AR 22-0001
Plambeck Gardens
23500 SW Boones Ferry Road

ARCHITECTURAL REVIEW BOARD
June 8, 2022

NW TRASH ENCLOSURE

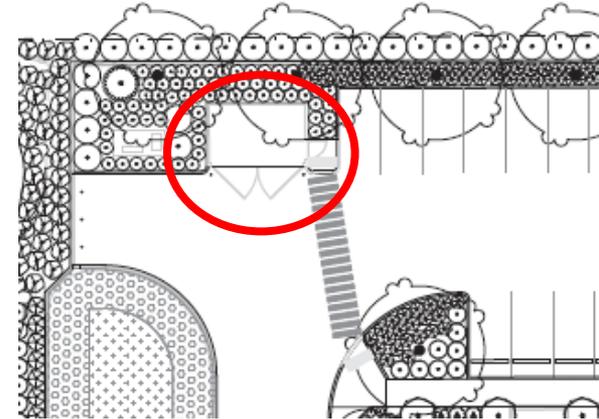
With conditions, the proposal complies with TDC 73D.070(2):

- Exterior storage areas must be enclosed by a sight obscuring fence or wall at least 6 feet in height.
- Vertical clearance of 8 feet is required if the storage area is covered.
